PRODUCT CHANGE NOTIFICATION: 2060 Series Surface Mount Terminal Block

Please be advised of the following product changes to WAGO's 2060 Series. Details of each are contained below:

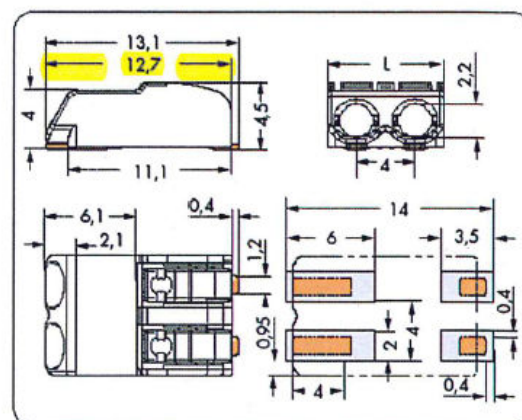
1) **Dimensional changes**—marked in Yellow in the drawings below

Increased housing length by 1mm at the rear of the terminal block. Total length of new variant is 12.7mm vs. 11.7mm of the old variant.

The increased housing length has the advantage of higher mechanical stability during pushbutton operation and for push-in insertion of solid wires (manual or automatic wiring). The metal contact has NOT been changed and therefore the PCB pad layout does NOT have to be changed to accommodate. In most applications there are no other objects/components positioned within the added 1mm length, and thus the terminal block can be changed to the new version without further consideration.

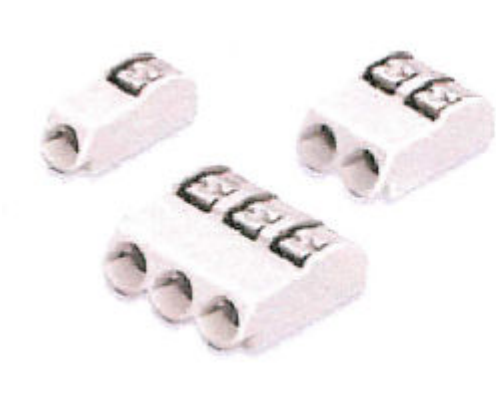
2) Color changes

The new variant features a pure white insulating housing color instead of a light-gray color of the old version. The advantage is better light characteristics—more reflection/less shadowing.
